From: Jesuthasan Mari raj [REDACTED]
Sent: 24 February 2026 13:50
To: Sanger, Jane <Jane.Sanger@wiltshire.gov.uk>
Subject: Re: PL/20205/08852 - 4 St John Street, Devizes

ADVERTISEMENT APPLICATION:

Revised signage attachment 1:

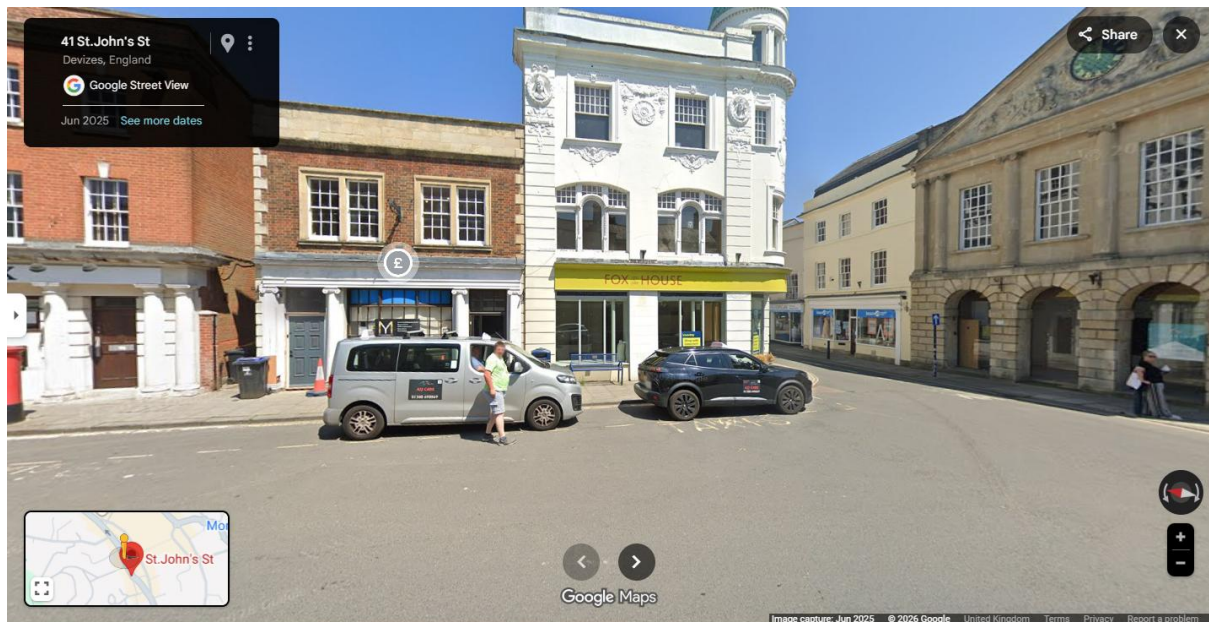
- The plans need to be to a recognized scale of 1:100 in order that we can measure electronically the position of the sign(s) on the building, and the size of the lettering (attachment 3 the originally submitted drawing was to a recognized scale);

- The size of the lettering and sections can be either at 1:100 or 1:20;
- All plans need the scale annotated on them and the related scale bar;
- It needs to include a section drawing showing the depth of the fascia sign and the projection of the lettering from the face of building (but hand painted lettering is preferred as set out below);

- This is a listed building, and an aluminum sign will NOT be acceptable, it needs to be timber sign with a painted finish, as was the case in the original submission. It is strongly recommended that the lettering is hand painted and not metal lettering. It is suggested that you repaint the existing timber sign;

- The proposed fascia needs to be reduced in its width to prevent the bottom of it overhanging the stonework, see the difference between the position of the fascia on originally submitted plan attachment 3, with your recent plans in attachment 1;

- Please state the RAL colours of the existing building/stonework on the Existing Elevations drawing;

- Note: this submission is outstanding an Existing Elevations drawing;
- The 'WILTSHIRE' lettering needs to be reduced slightly in size;
- Please annotate the RAL Colour Numbers of the fascia board and lettering on the revised elevation drawings and on the required Existing Elevations drawing, that will need to be submitted;
- It would be more desirable if the lettering was a dark grey colour rather than a stark black;
- Please revise the drawing to clearly show the curved corner of the building, please see how this is done in attachment 3;
- The background colour of fascia board needs to be a more neutral tone, stone colour or white, similar to the neighbouring buildings on the photo below:
